NAME OF CUSTOMER: NABINAGAR POWER GENERATING CO. PVT. LIMITED (NPGC)
NAME OF PROJECT : 400/132 KV SWITCHYARD PACKAGE AT NABINAGAR SUPER THERMAL POWER PROJECT (3 X 660 MW)

400KV NABINAGAR TPP (BRBCL) EXTN – SINGLE LINE DIAGRAM

NTPC DRAWING NO. 0370-572-PVE-F-442				
CUSTOMER NABINAGAR POWER GENERATING CO. PVT. LTD. (NPGC)				
PROJECT : NABINAGR STPP (3X660 MW) 400/132kV SWITCHYARD PACKAGE				
CONTRACTOR 	BHARAT HEAVY ELECTRICALS LTD. TRANSMISSION PROJECTS DIVISION NEW DELHI	DEPT CODE DRN CHD APPD	NAME RK SK DKM/RS	SIGN
TITLE Equipment Earthing Philosophy & Details				
DEPT.	SCALE	DRAWING NO. TB-4-350-316-017		
SIGN		SHEET 01 OF 22		
DATE		REV. 00

EQUIPMENT EARTHING DETAILS NOTES

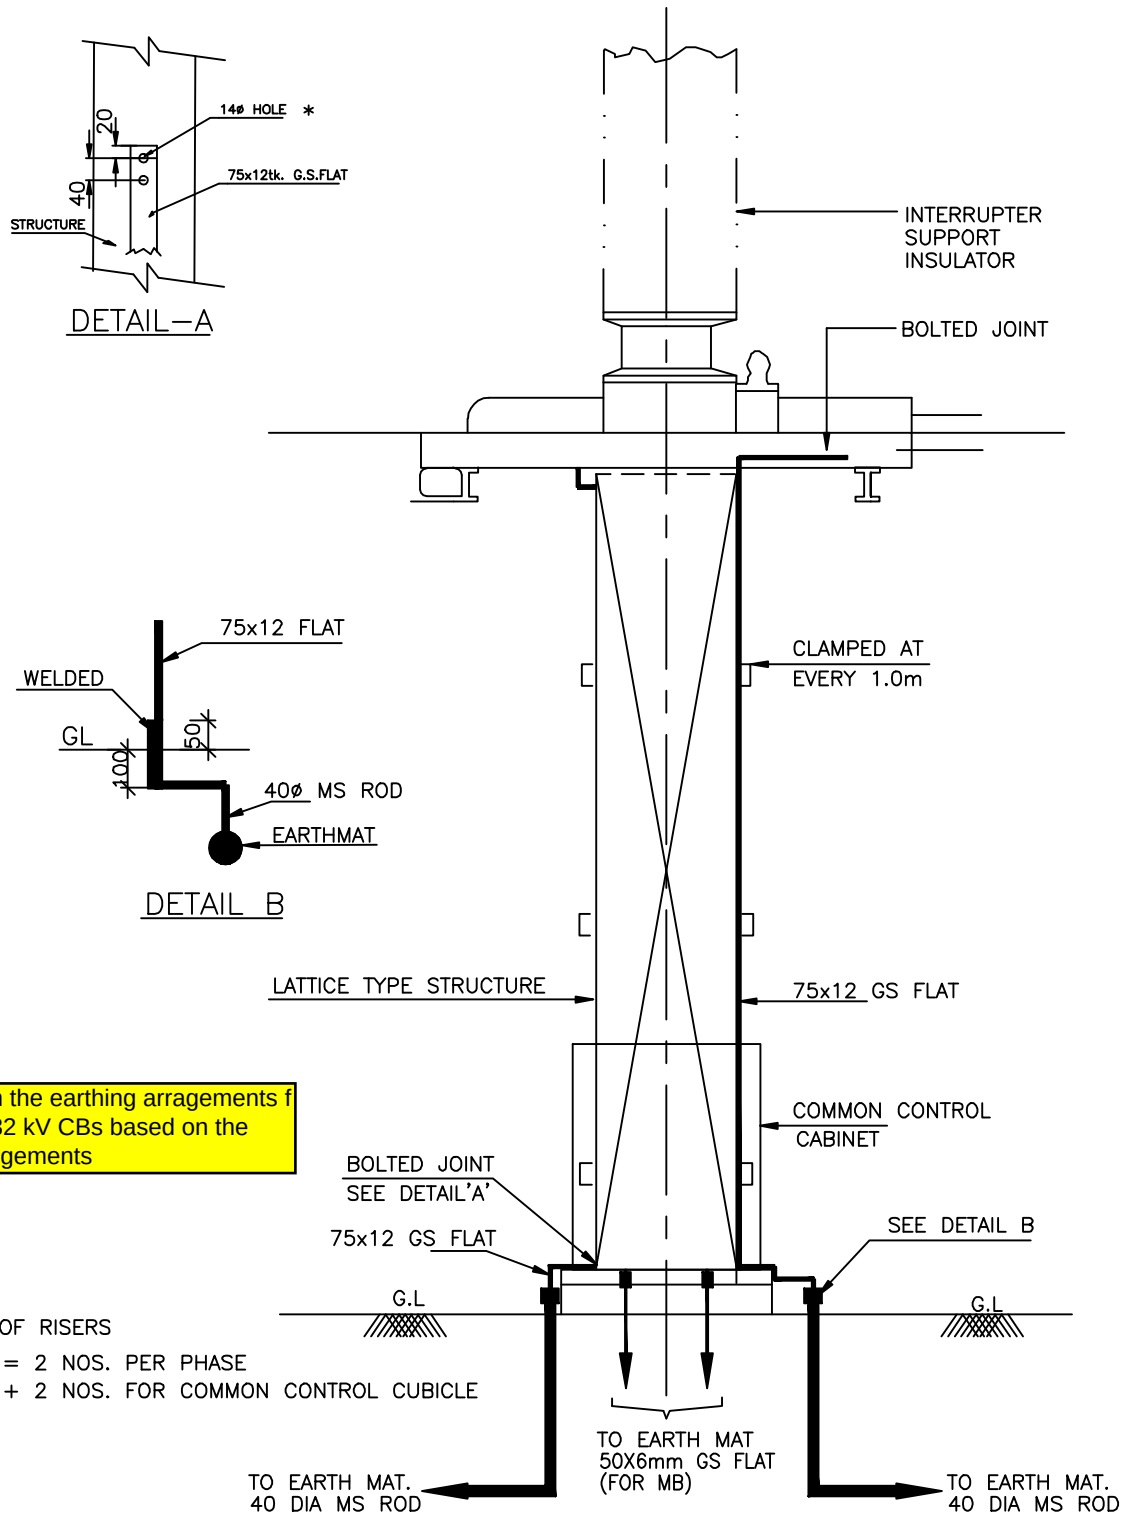
Rod shall be spec requirements/ approval

Pl refer Annexure-I of Chapter-E13 of tech spec for earthing requirements.

400kV & 132kV SF6 CIRCUIT BREAKER

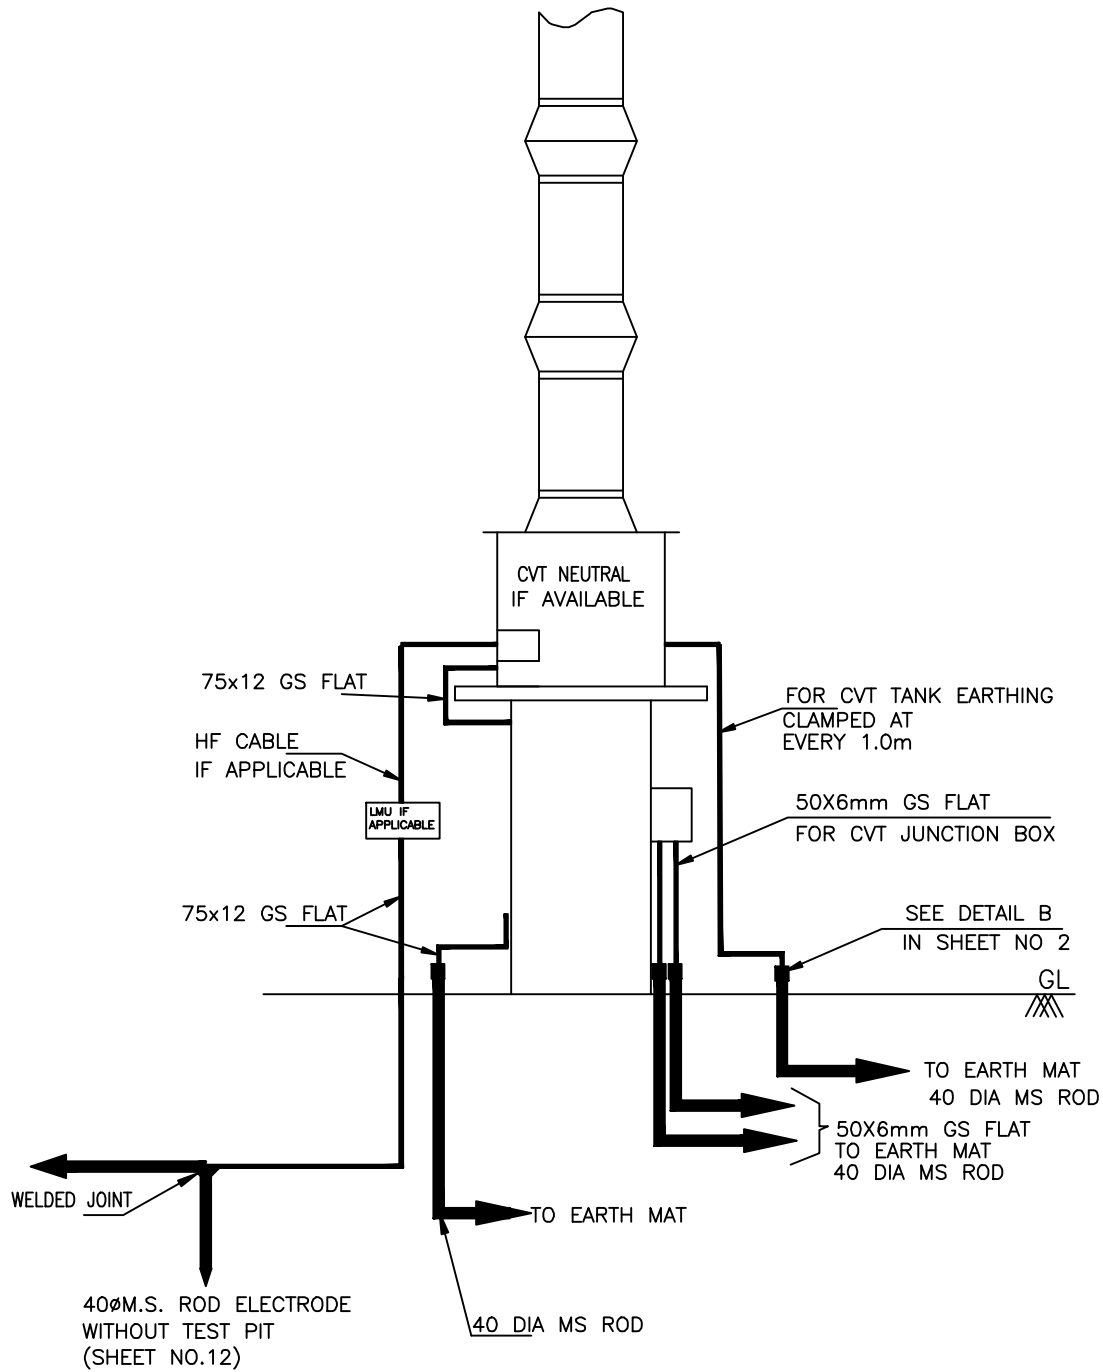
Please furnish the earthing arrangements for 400kV & 132 kV CBs based on the general arrangements

EQUIPMENT EARTHING DETAILS LIGHTNING ARRESTER (390kV, 120kV & 30 kV)

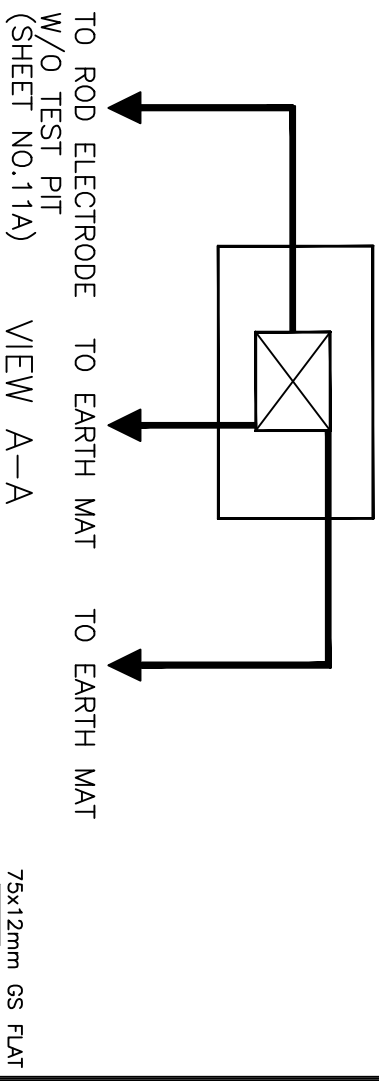
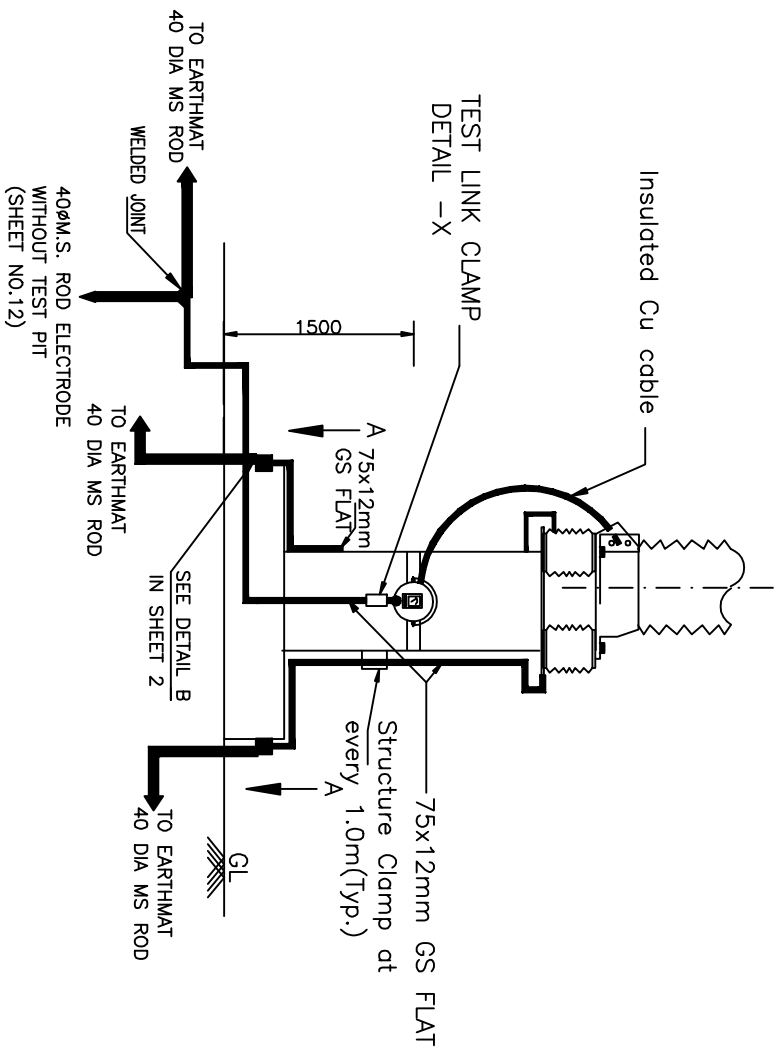
Please furnish the dimensions and details of not & Bolts

400KV HORIZONTAL CENTER BREAK ISOLATOR (TYPICAL) WITH ONE EARTH SWITCH

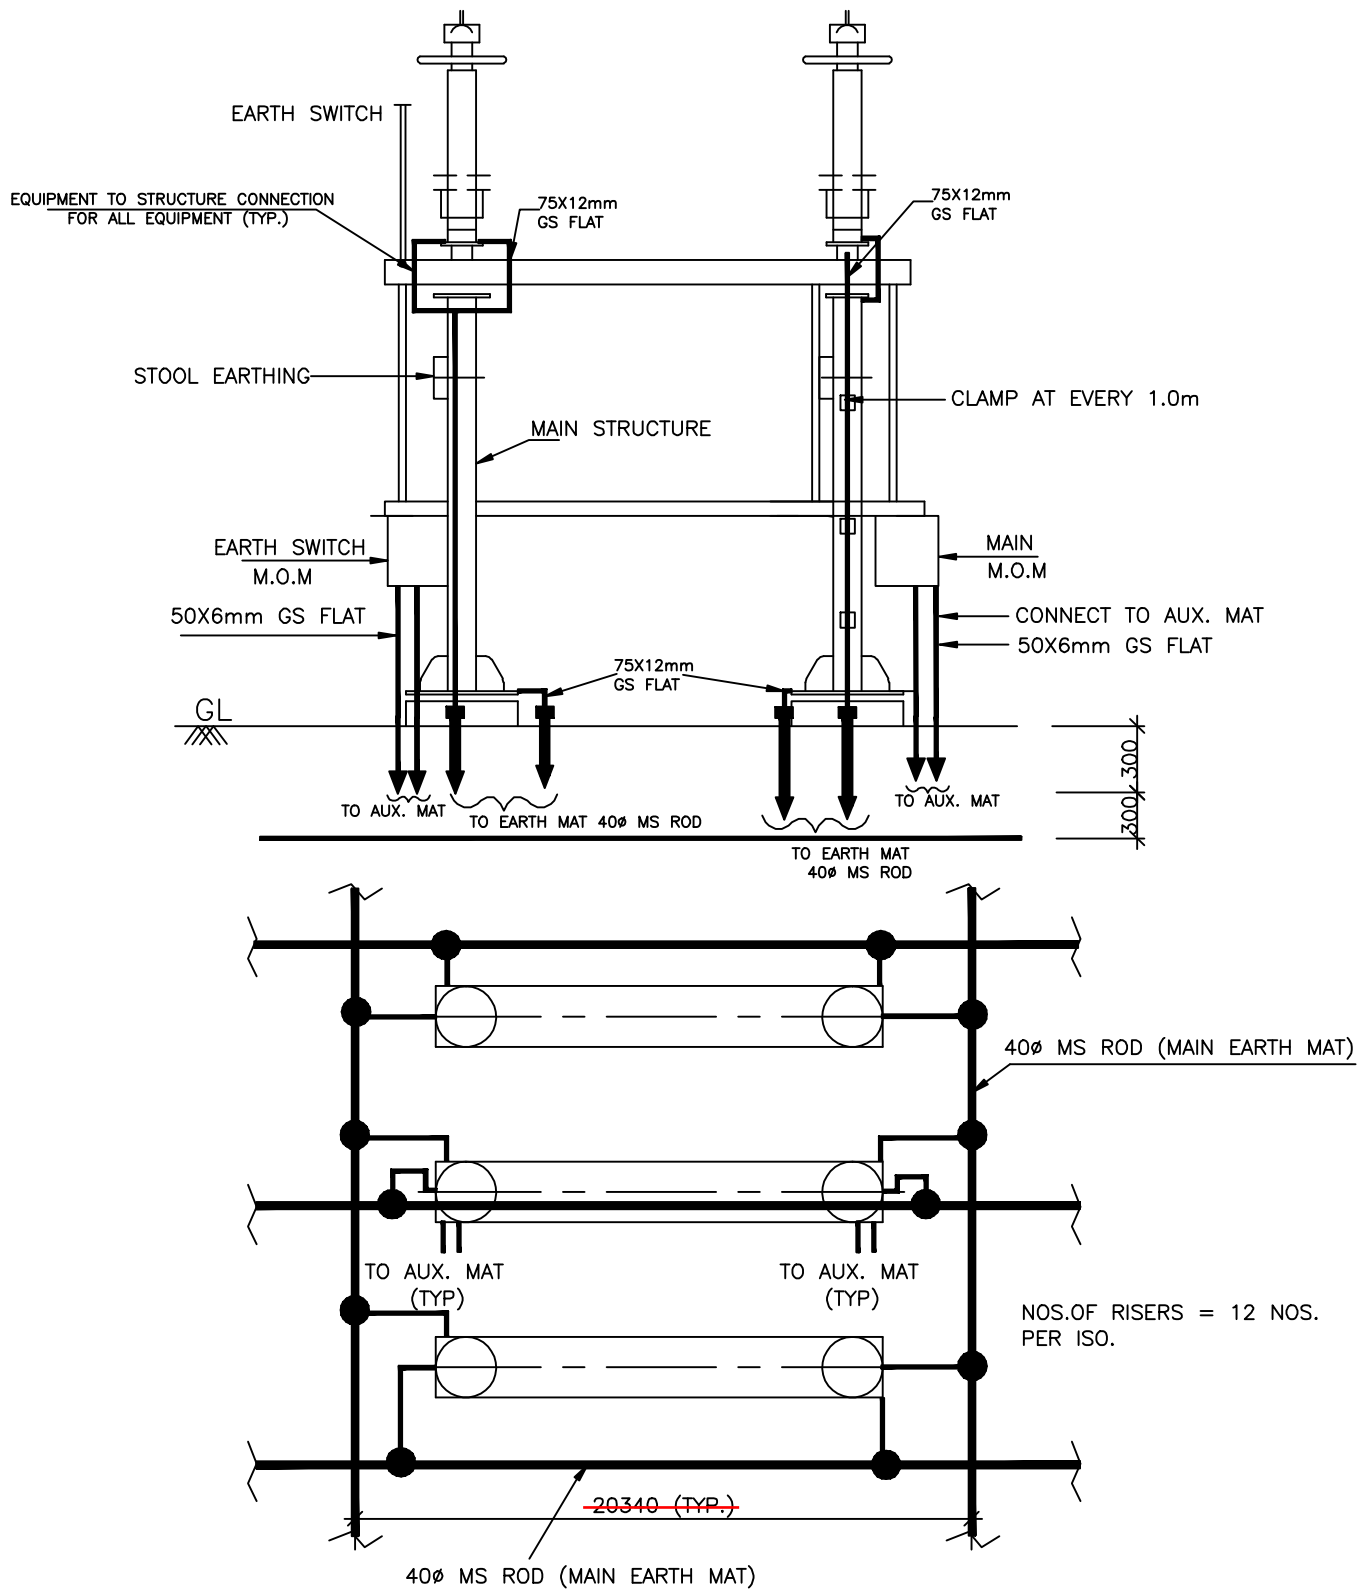
M/s BHEL to ensure the Isolator arrangement drawing

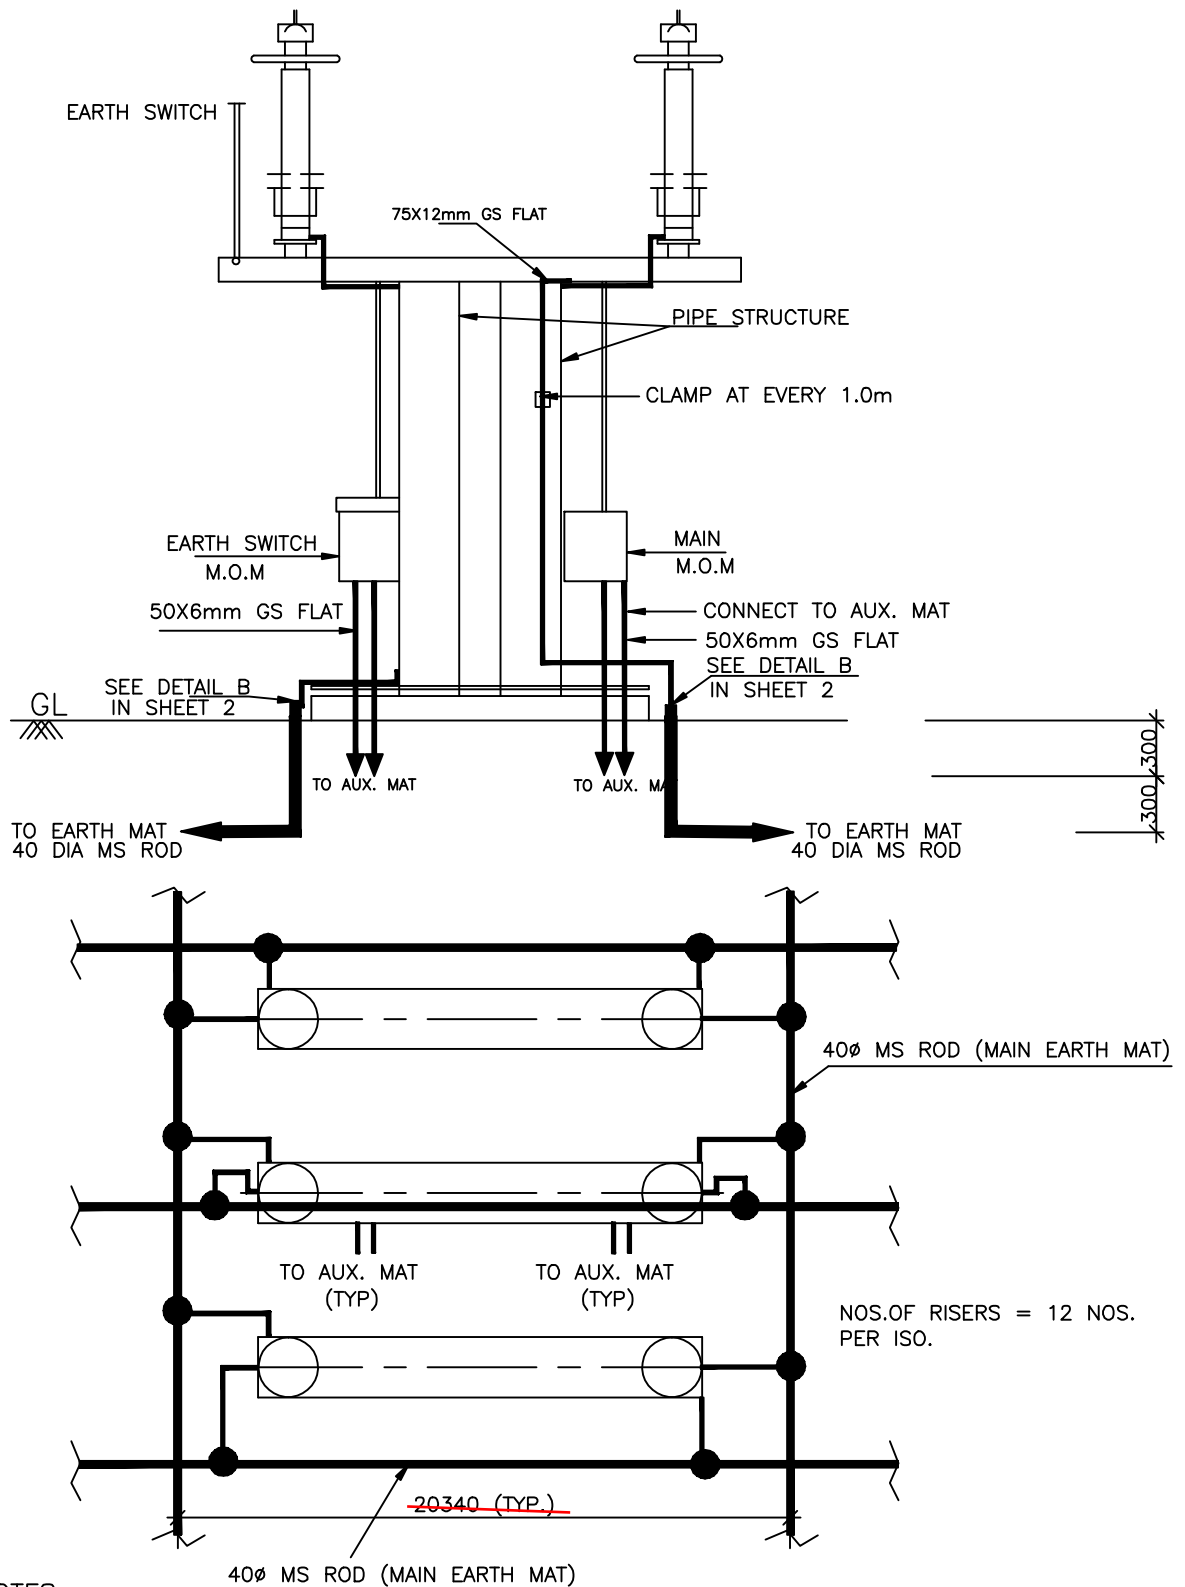
M/s BHEL to ensure the Isolator arrangement drawing

132 kV HORIZONTAL CENTER BREAK ISOLATOR WITH ONE EARTH SWITCH

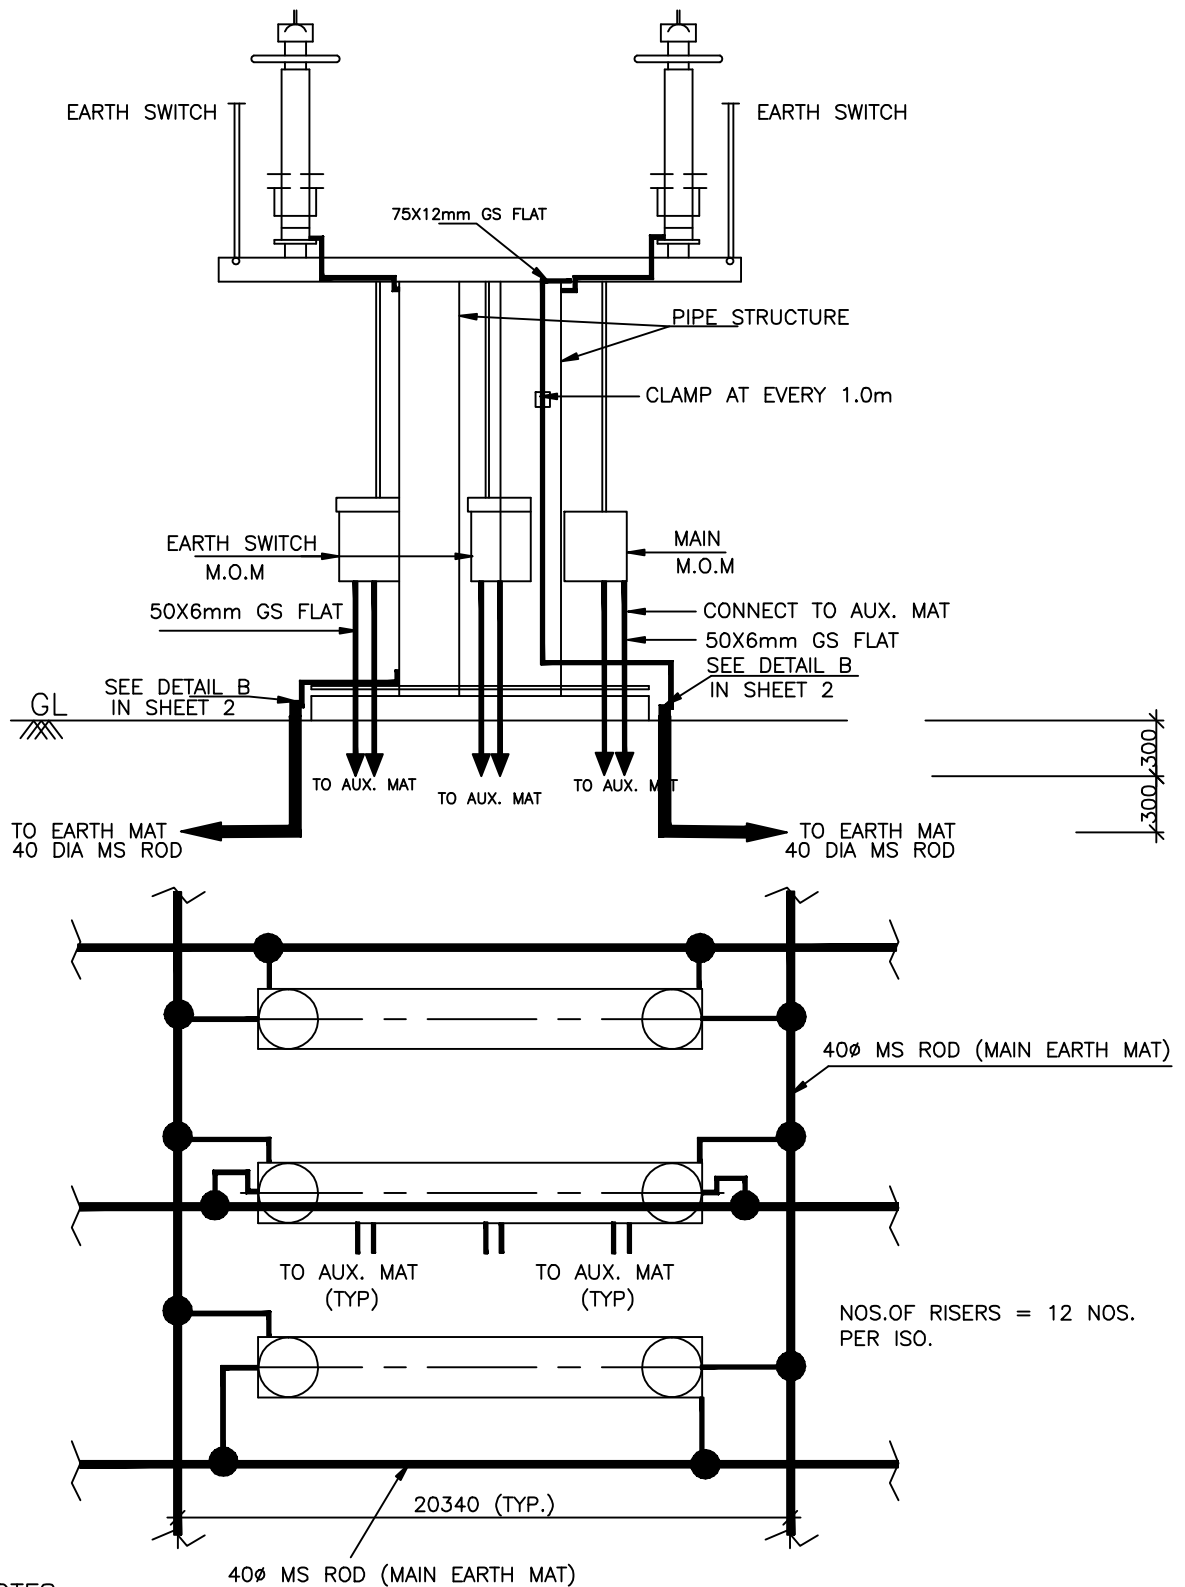
M/s BHEL to ensure the Isolator arrangement drawing
